# Access Compliance Report

## Public Rights-of-Way

### (Curb Ramps)

Intersection ID: 10023487	Main Street: CIRCUMFERENTIAL_RD	Cross Street: N/A	Location: W
ADA ID: 57E27C5C6292	Ramp Type: PerpDiag	Initial Pass/Fail: Fail	Overall Compliance: No
		Severity Score: 12.5

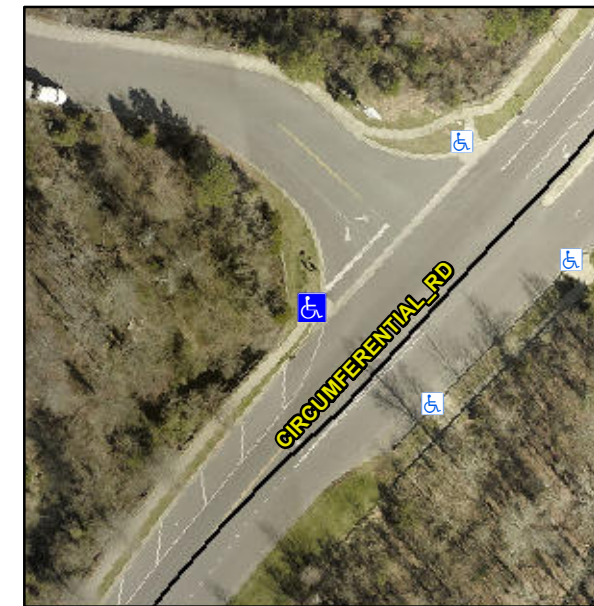
**Not Found, R304.5.3**

Compliance	Description	Data	Compliance	Description	Data
N/A	Ramp Length (in)	85.0	Yes	Ramp Slope (%)	7.1
Yes	Ramp Width (in)	48.0	No	Ramp XSlope (%)	5.8
N/A	Flare Type LT	N/A	N/A	Flare Type RT	N/A
N/A	Flare Slope LT (%)	N/A	N/A	Flare Slope RT (%)	N/A
N/A	Flare Traversable LT?	N/A	N/A	Flare Traversable RT?	N/A
N/A	Landing Length (in)	N/A	N/A	DWS Provided?	N/A
N/A	Landing Width (in)	N/A	N/A	DWS Contrast?	N/A
N/A	Landing Slope (%)	N/A	N/A	DWS Length (in)	N/A
N/A	Landing X Slope (%)	N/A	N/A	DWS Full Width?	N/A
N/A	Landing Curb? (Y/N)	N/A	N/A	DWS Offset (in)	N/A
N/A	Shared Landing?	N/A			
N/A	Gutter Ponding?	N/A	N/A	Gutter Slope (%)	N/A
N/A	Gutter Lip Ht (in)	N/A	N/A	Gutter X Slope (%)	N/A
N/A	Painted X Walk1?	No	N/A	Painted X Walk2?	No
	X Walk 1 Direction	To SE		X Walk 2 Direction	To NE
N/A	X Walk 1 Width (in)	N/A	N/A	X Walk 2 Width (in)	N/A
	X Walk 1 Slope (%)	1.7		X Walk 2 Slope (%)	2.4
	X Walk 1 X Slope (%)	3.0		X Walk 2 X Slope (%)	3.5

**Remove & Replace Curb Ramp With Two New Directional Ramps or Equivalent.**
